USNRC APPLICATION
SUA-1341 License Amendment
Ludeman Project
Converse County, WY

TECHNICAL REPORT
REQUEST FOR ADDITIONAL INFORMATION
RESPONSE PACKAGE

June 2013

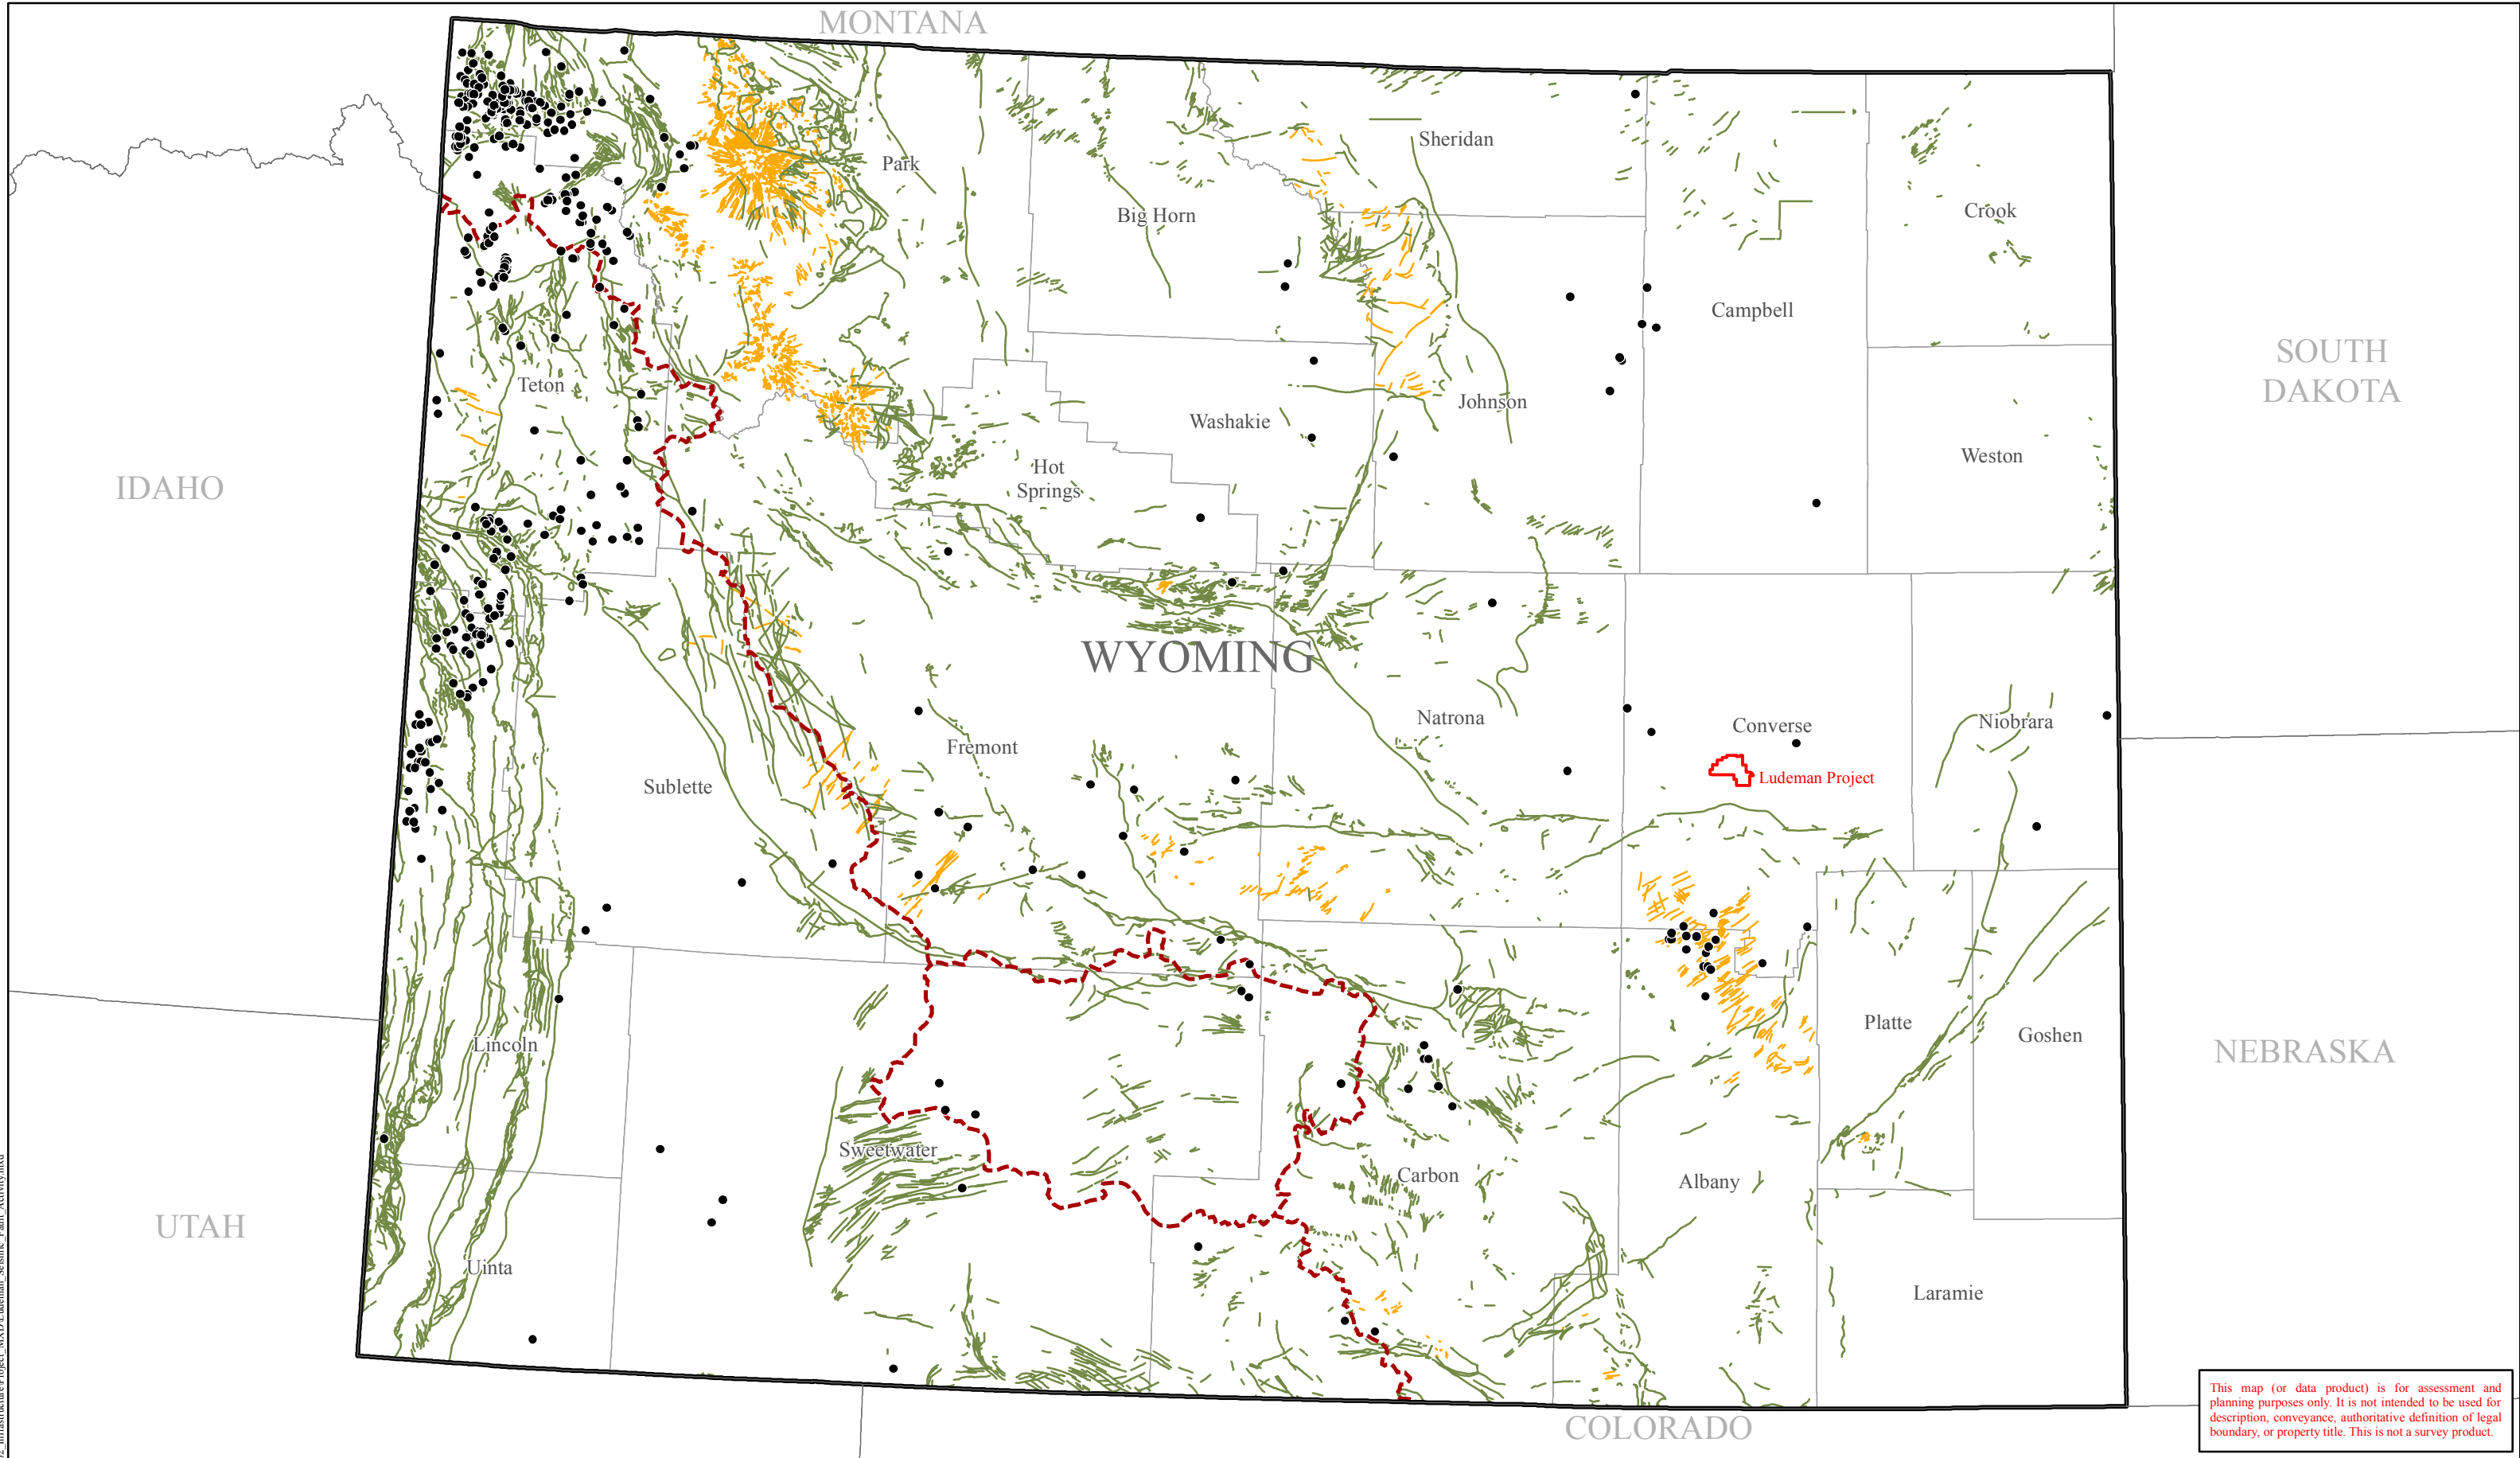
Please provide information on the potential for seismicity induced by the deep-well injection of waste water proposed for the Ludeman Project.

The figure below has been added to ER Section 3.3 to illustrate known faults in relation to the project area:
